MINIMUM INSPECTION PROCEDURAL GUIDELINES
FOR BUILDING ELECTRICAL RECERTIFICATION

a. Name on Title: Village at Dadeland Condominiums (J)

b. Street Address: 7600 SW 82nd St. Miami, Florida 33143

Photo 1 – Village of Dadeland Condominium Association

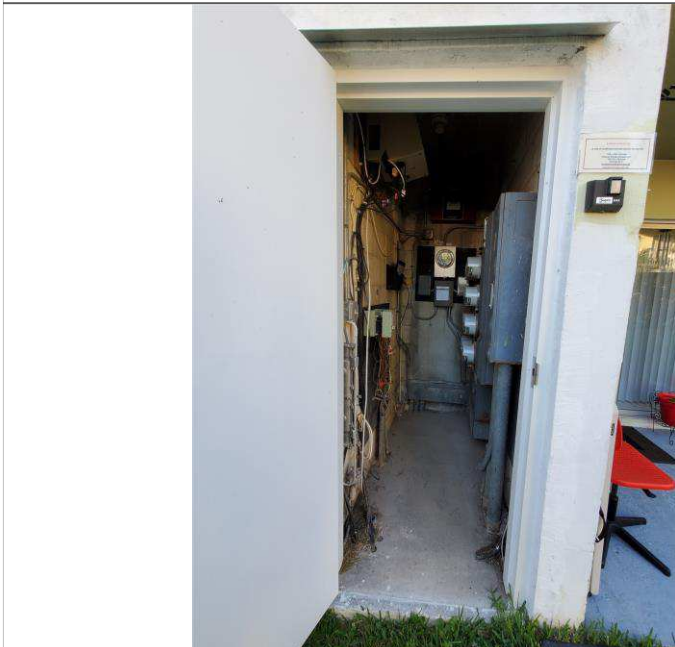
Existing Electrical Room - 1st FL
Provide sign with Building
Number

Photo 9 – Village of Dadeland Condominium Association

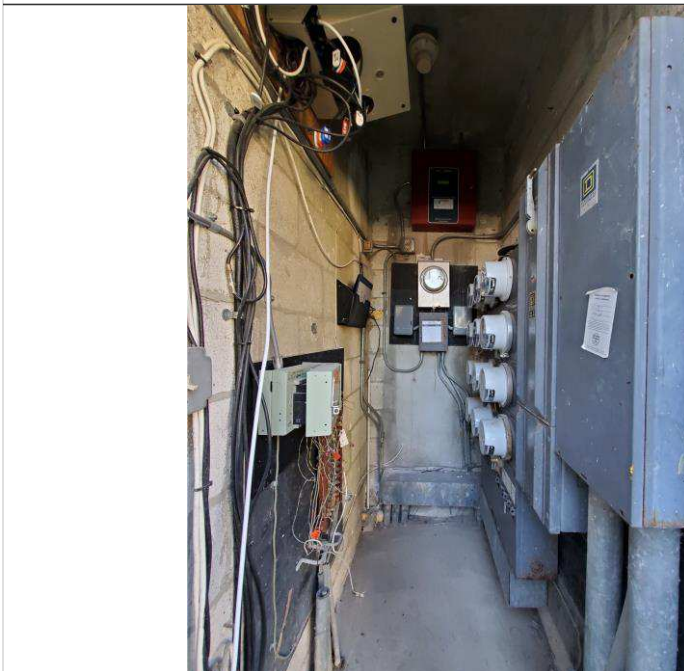
Old and oxidized meter stacks.

Old Breakers

Photo 12 – Village of Dadeland Condominium Association

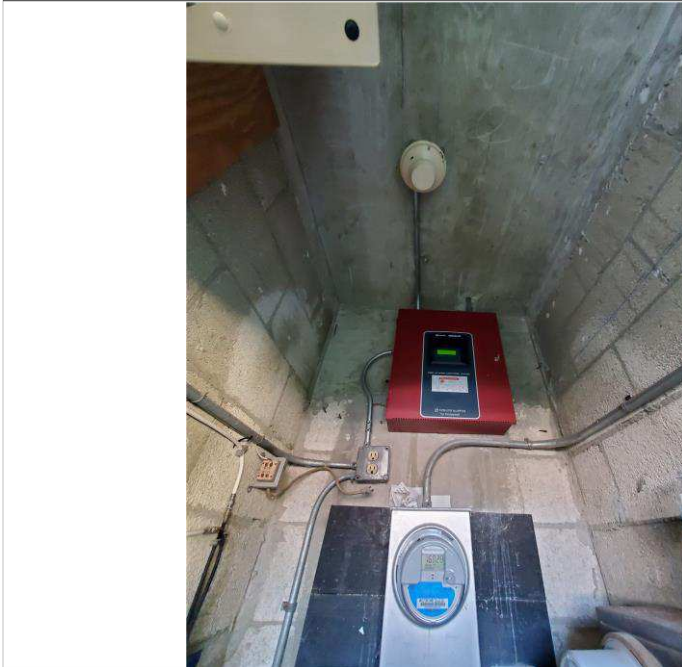
Junction boxes not properly supported.

Photo 14 – Village of Dadeland Condominium Association

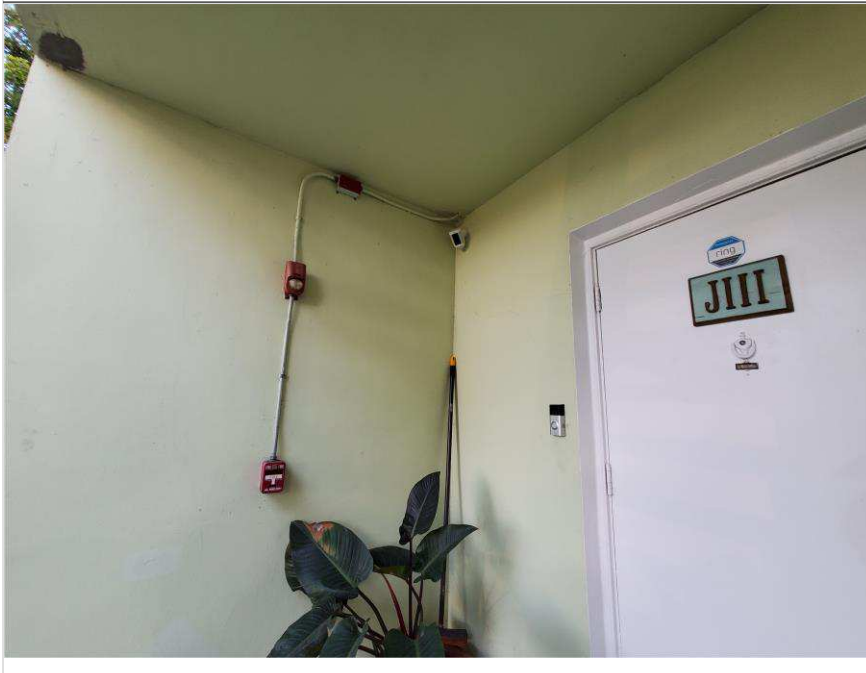
Level 1
Fire Alarm - Old and Weathered
Fire Alarm Devices and Control
Center

Old Strobe Horn/Strobe Device

Photo 15 – Village of Dadeland Condominium Association

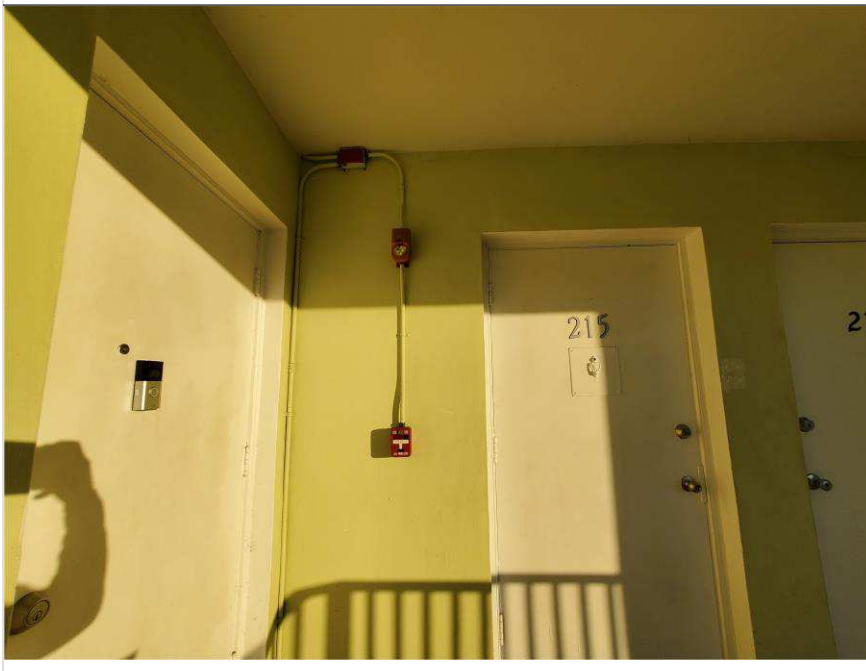
Fire Alarm - Old and Weathered
Fire Alarm Devices and Control
Center

Old Strobe Horn/Strobe Device
and Pull Stations

Photo 21 – Village of Dadeland Condominium Association

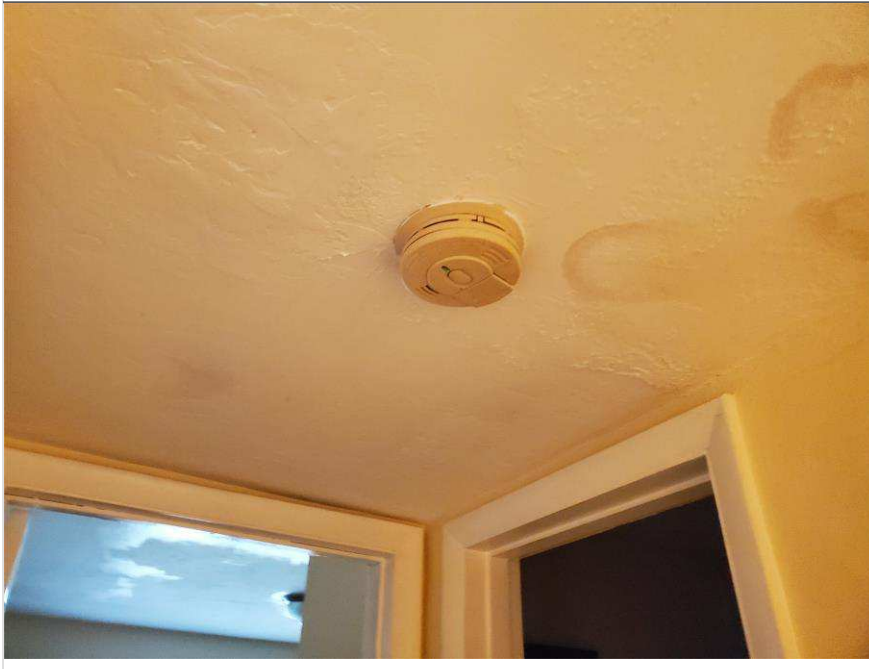
Apartments - Balcony/Patio
outlets not GFCI type.

Photo 1 – Village of Dadeland Condominium Association

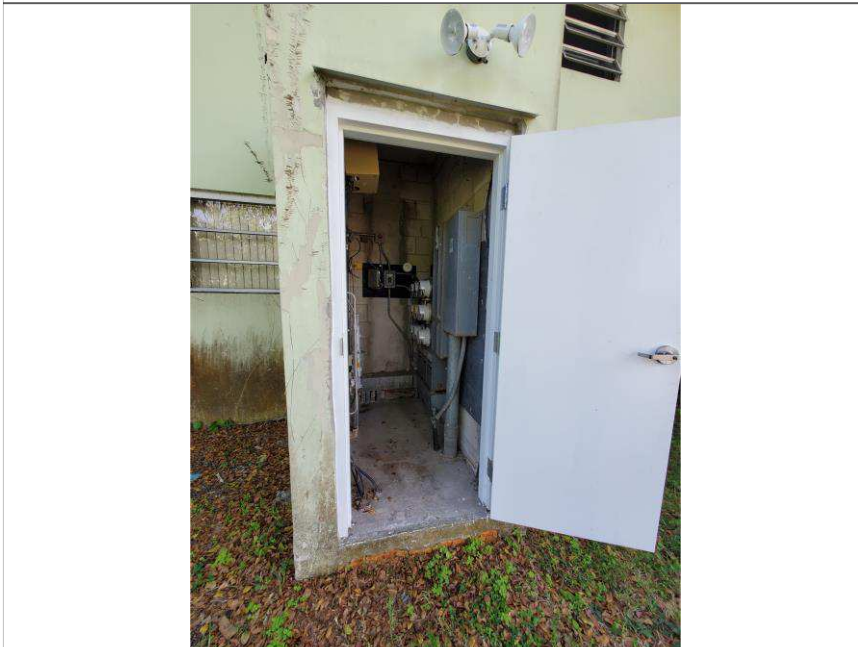
Existing Electrical Room - 1st FL
No Storage Permitted

Missing sign with room name
and building number.

Photo 4 – Village of Dadeland Condominium Association

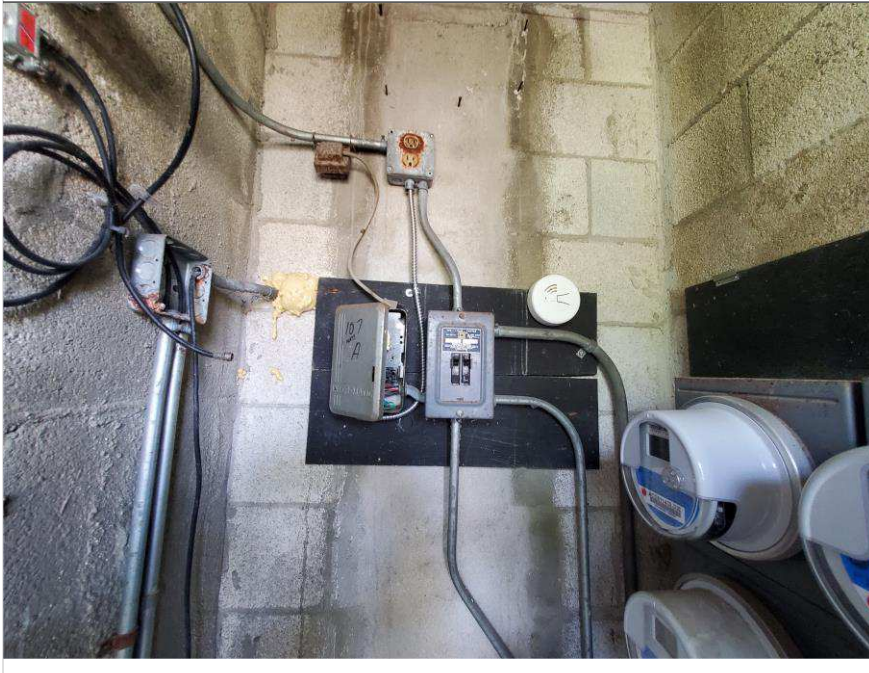
Oxidized tops and taps of
Electrical Components.

Photo 5 – Village of Dadeland Condominium Association

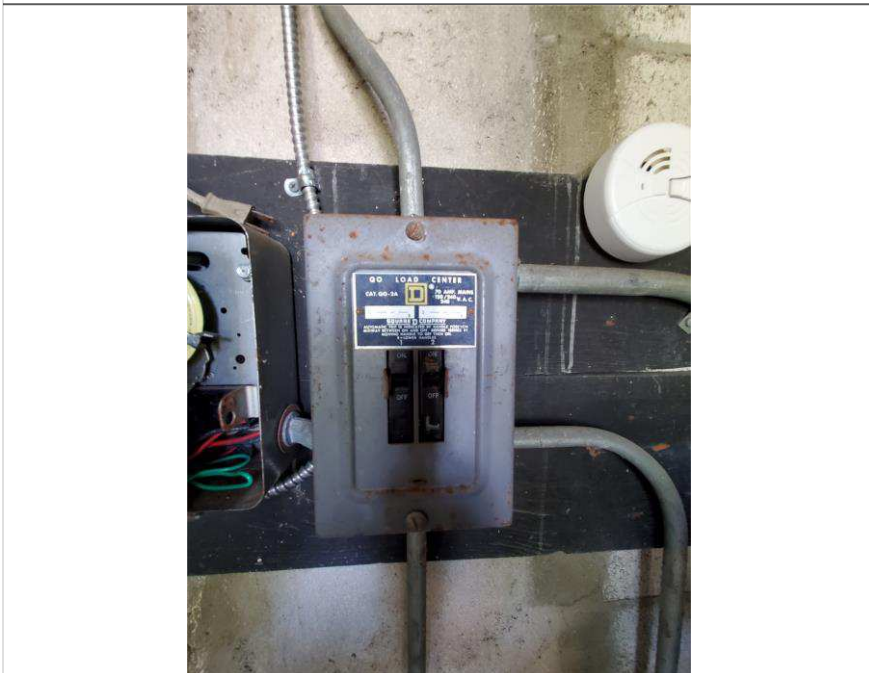
Corroded electrical outlet.
Open junction boxes to be
closed.

All wall penetrations to be fire
caulked.

Photo 9 – Village of Dadeland Condominium Association

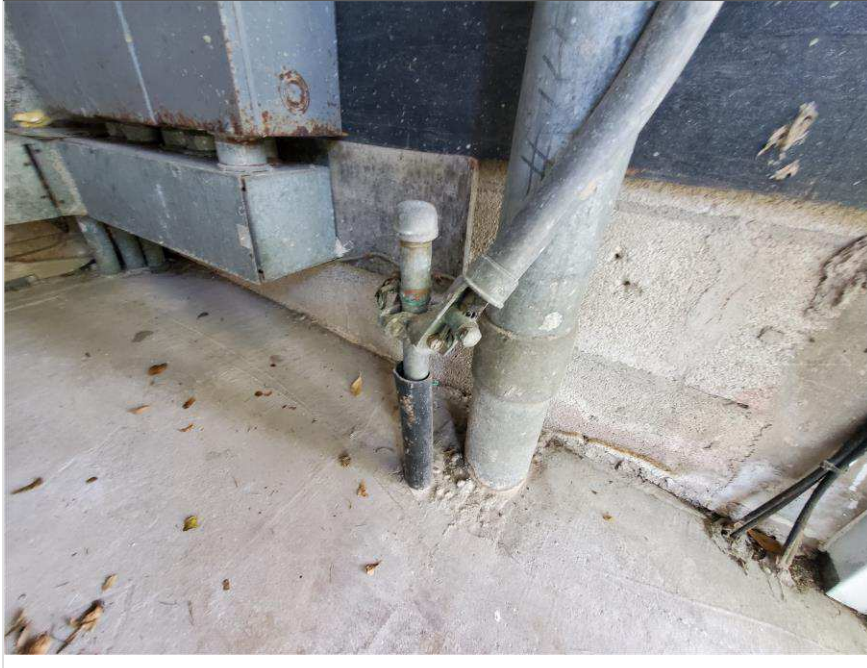
Insufficient clearance at
electrical components.

Photo 13 – Village of Dadeland Condominium Association

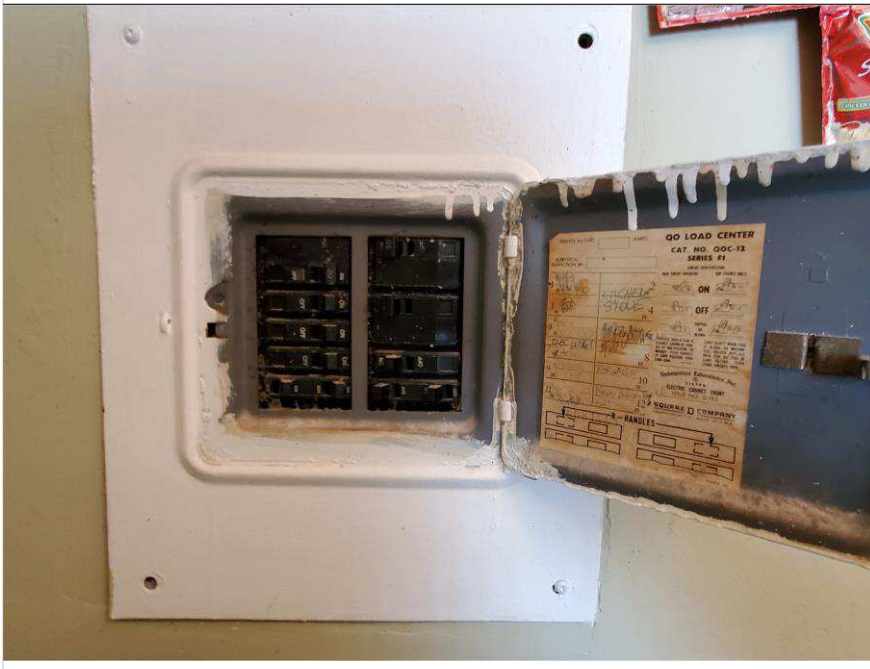
Points of Egress -
Insufficient illumination at
catwalks, stairs, and sidewalks.
Exterior lights not functional

Parking
Insufficient illumination at
sidewalks and parking spaces.

Photo 17 – Village of Dadeland Condominium Association

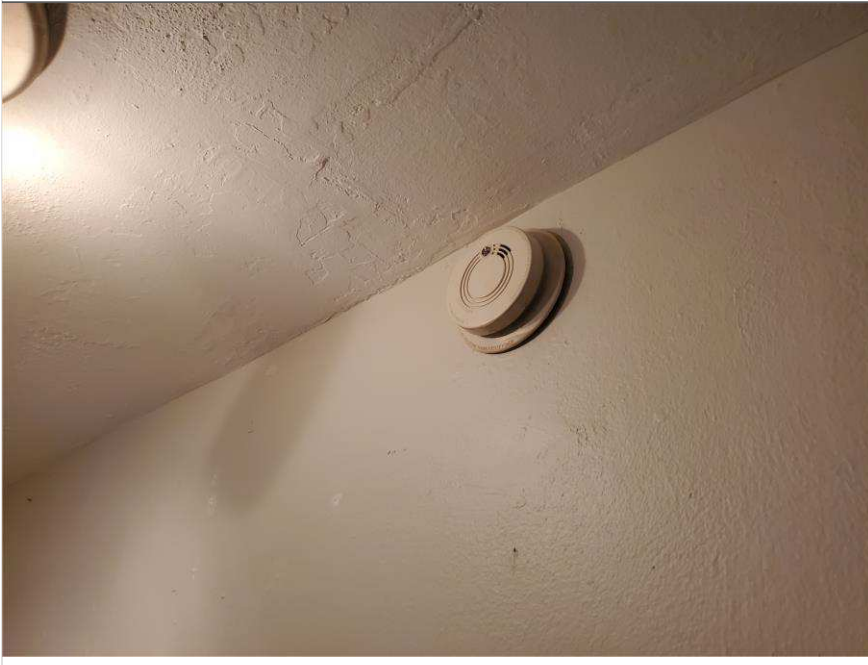
Apartments - Balcony/Patio outlets are not GFCI type.

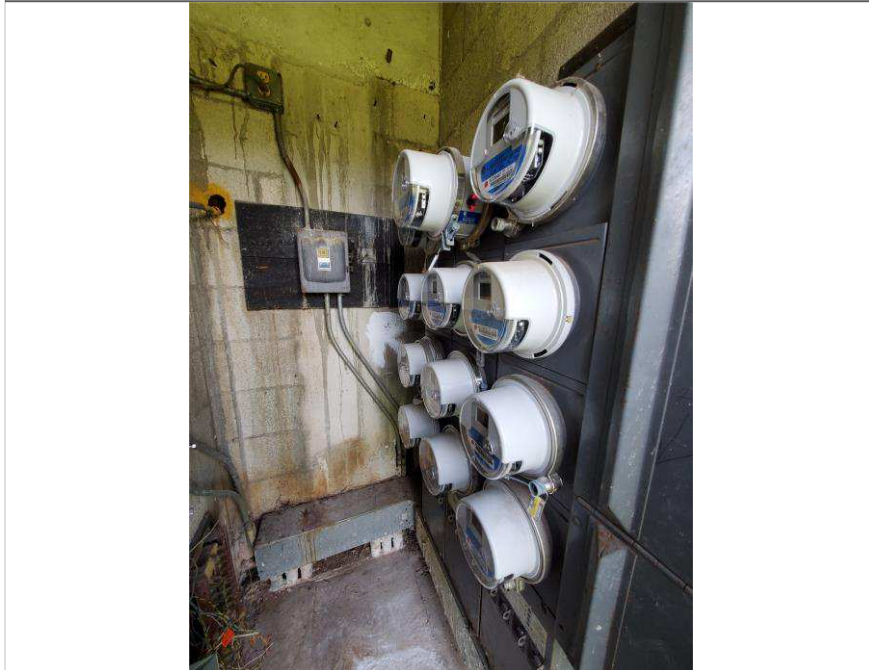
House Panel Board installed in front of Water Heater.

There is insufficient clearance in front of panel.

Photo 8 – Village of Dadeland Condominium Association

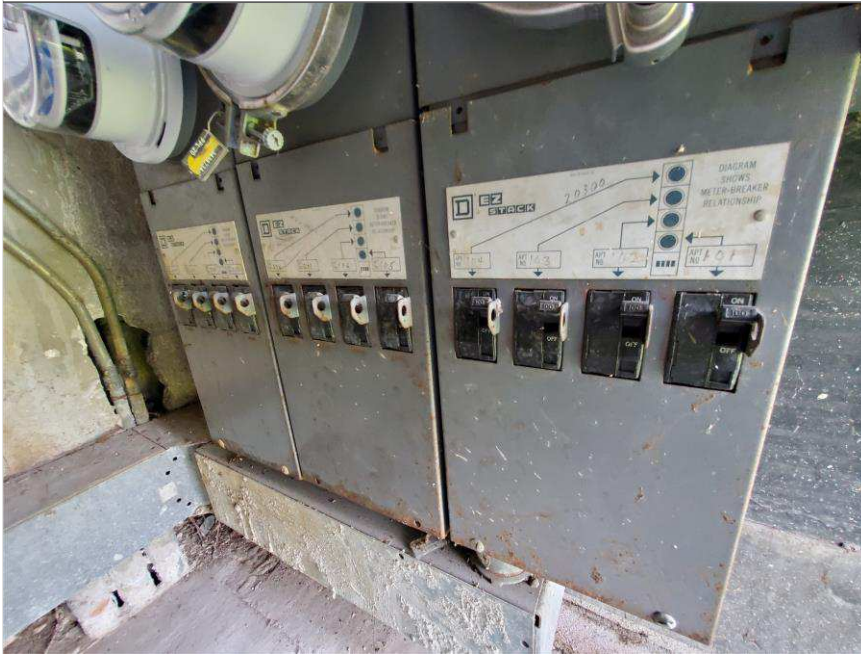
Old and oxidized meter stacks.

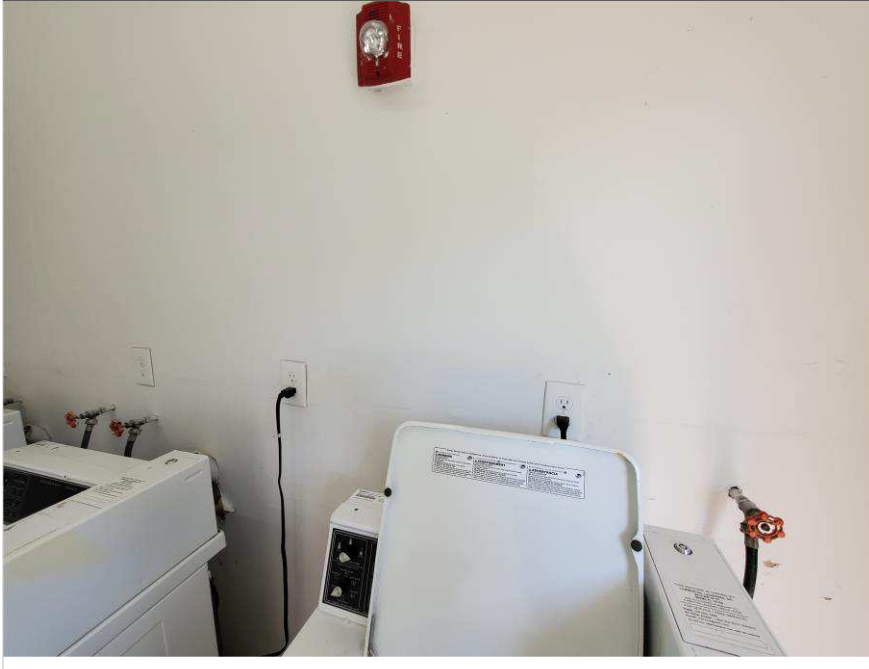
Exterior lights not functional.

Insufficient illumination at Stairs sidewalk, and Catwalks.

Photo 21 – Village of Dadeland Condominium Association

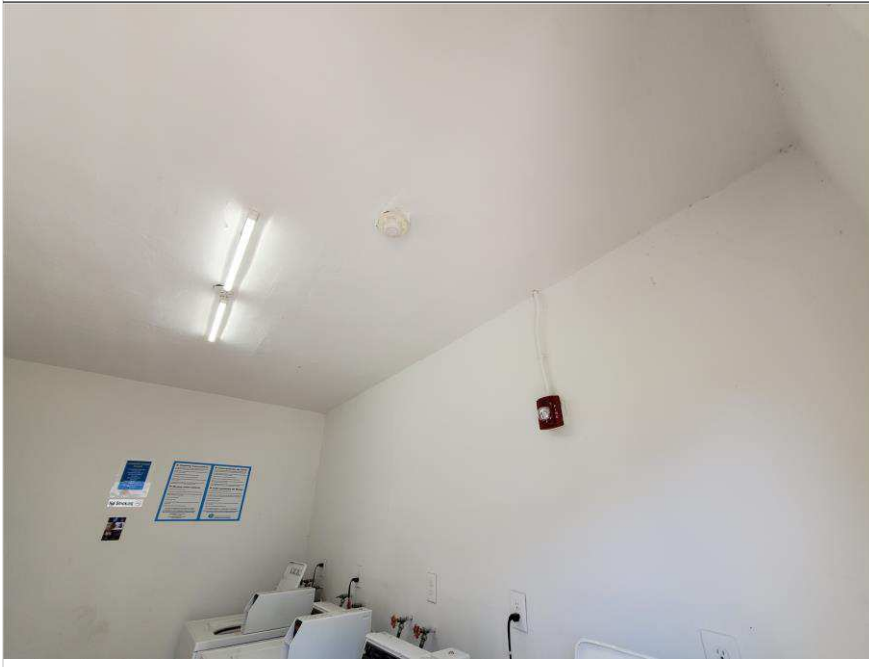
Laundry Room - Outlets are not GFCI type.

Photo 22 – Village of Dadeland Condominium Association

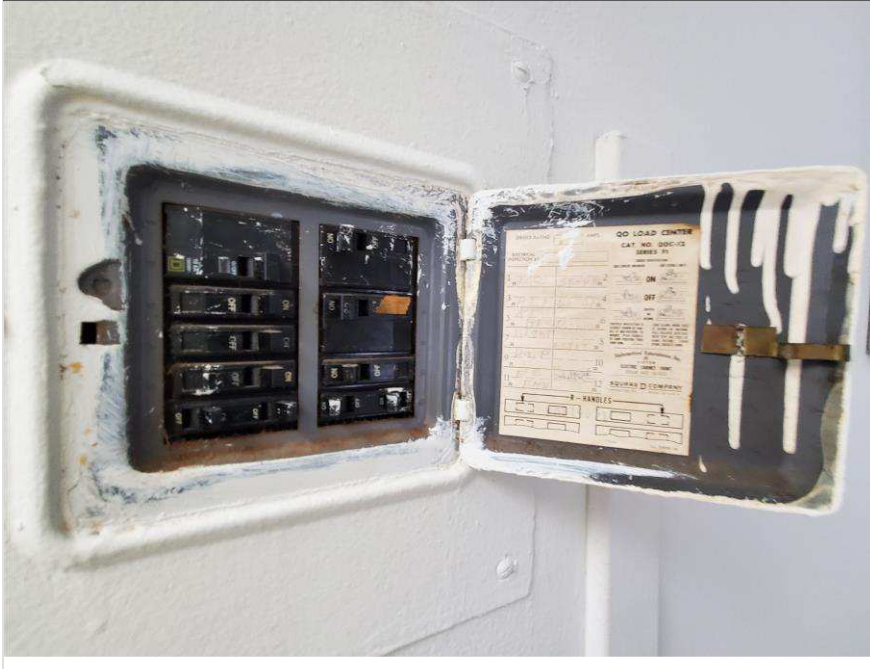
Old smoke detector.

Photo #5:

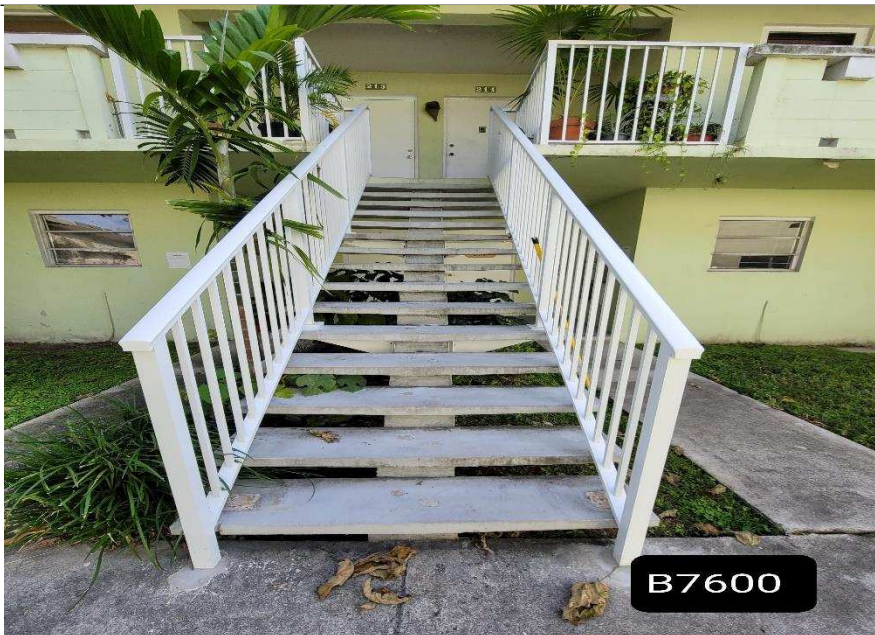
The strainers for the interior drain lines were found to be rusted or non-functional since many of them are missing or not in their proper position. Others need maintenance to remove debris.

Photo #3:

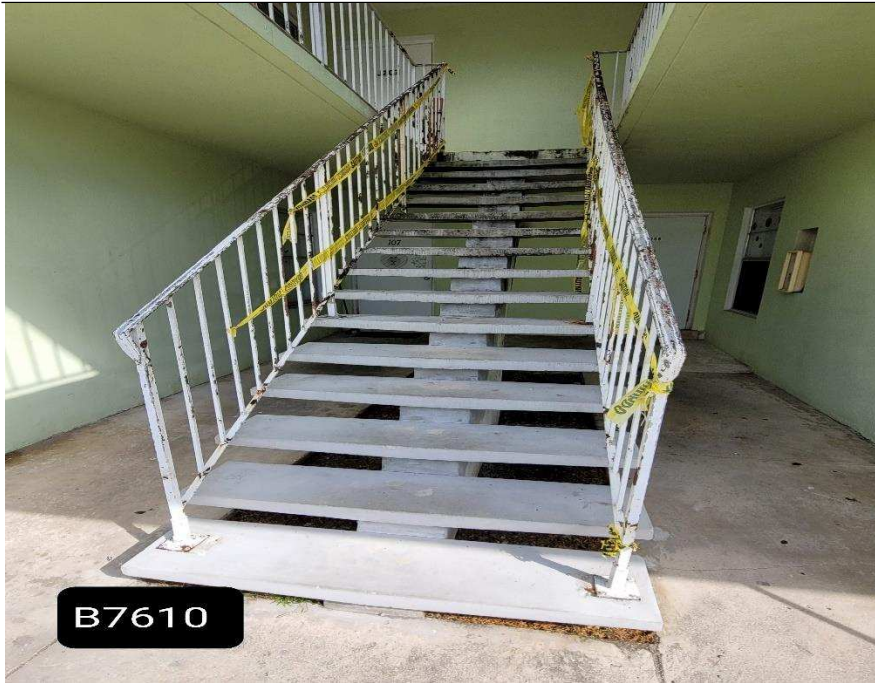
Replacement of the steel picket rails is necessary due to the extent of corrosion at the base of the rail posts.
